Chip Errata for the MB9AB40N/A40N/340N/140N Series, FM3 Family Microcontroller

This document describes the errata for the MB9AB40N/A40N/340N/140N Series FM3 Family Microcontroller. Details include Flash memory dual operation problems, scope of impact and available workarounds. Compare this document to the device's data sheet for a complete functional description.

Part Number
MB9AB40N/A40N/340N/140N Series

Figure 1. FLASH Memory MAP

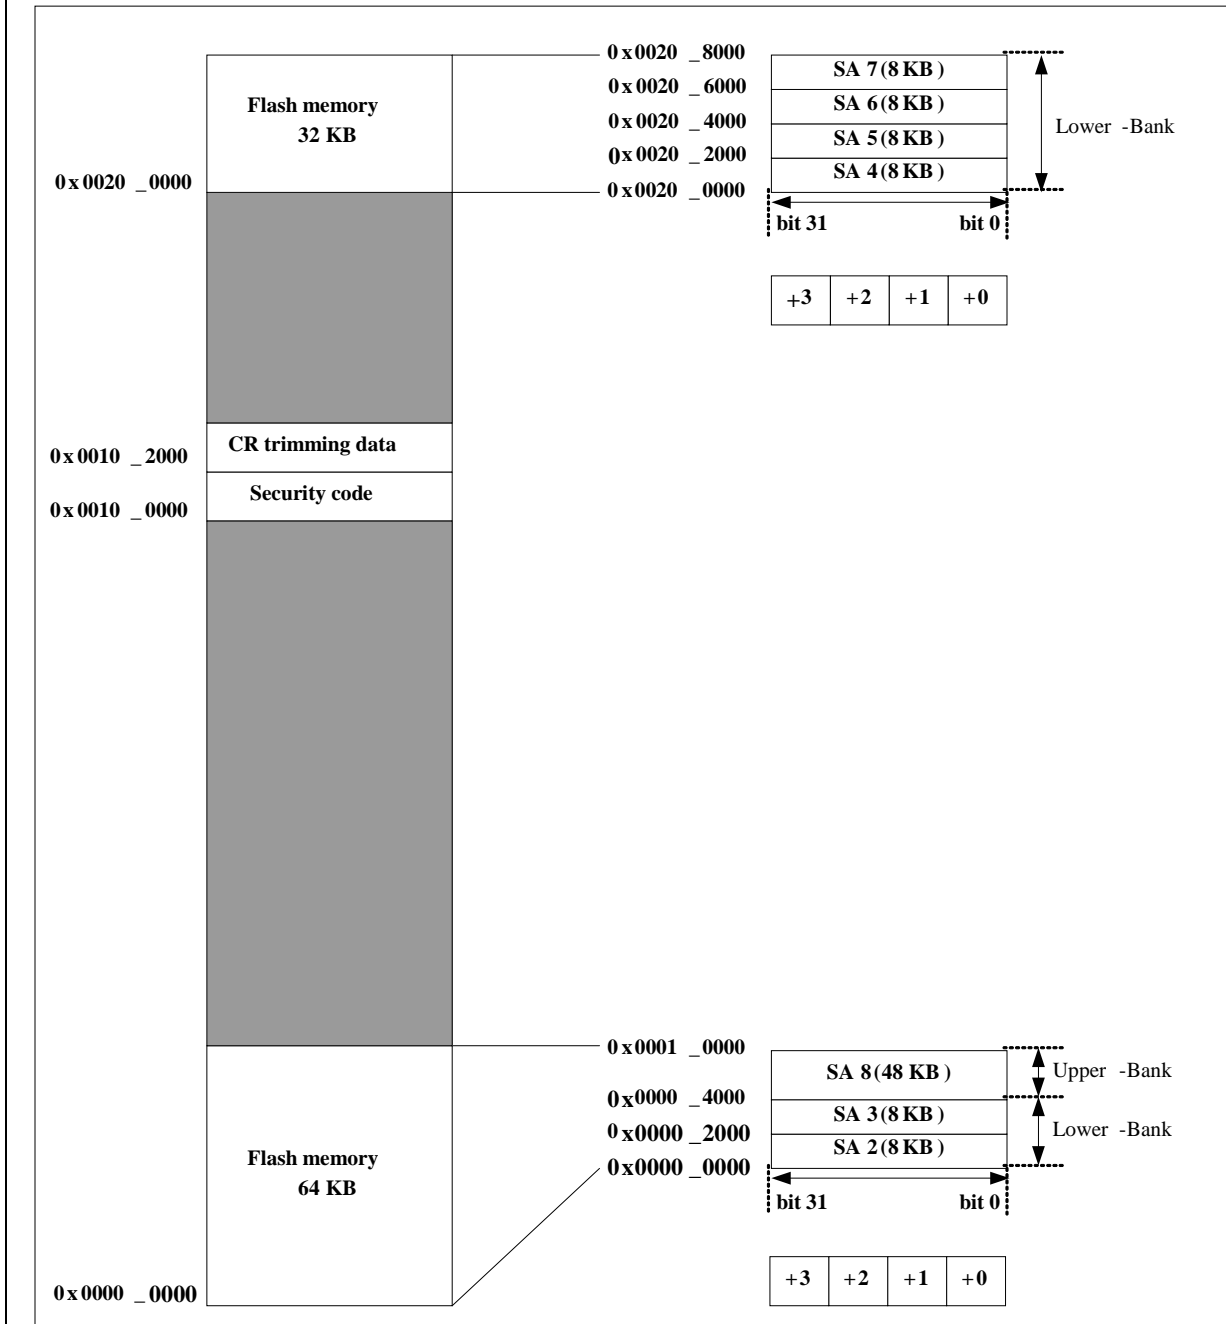
(1) Occurrence Conditions of Problem 1

At the specific timing, the FLASH memory lower bank (smaller sector) is not correctly read while writing(programming) to the FLASH memory upper bank (larger sector). Therefore, the instruction in the lower bank could not be read correctly and the writing sequence to the upper bank executed by the instruction would lead to a hard fault or run-away. Moreover, when the lower bank is read while writing to the upper bank by the instruction on RAM, an incorrect value might be read.

The problem occurs at the combination of the following operations.

Upper bank (Larger sector)	Lower bank (Smaller sector)	Judgment
Instruction/data reading		Normal operation
Instruction/data reading	Writing	Normal operation
Instruction/data reading	Sector erase	Normal operation
Writing	Instruction/data reading	At a specific timing, a correct value could not be read.
Sector erase	Instruction/data reading	Normal operation
FLASH memory(all sectors) erase		Normal operation

- Countermeasures against Problem 1

To rewrite the upper bank of FLASH memory, store the write instruction in RAM instead of the lower bank and read the instruction from RAM to execute. Do not access the lower bank until the write operation is completed (RDY=1). Especially to disable the vector fetch to the lower bank of the FLASH memory at an interrupt occurred, the interrupt should be prohibited or the vector address should be set to RAM by the vector table offset register.
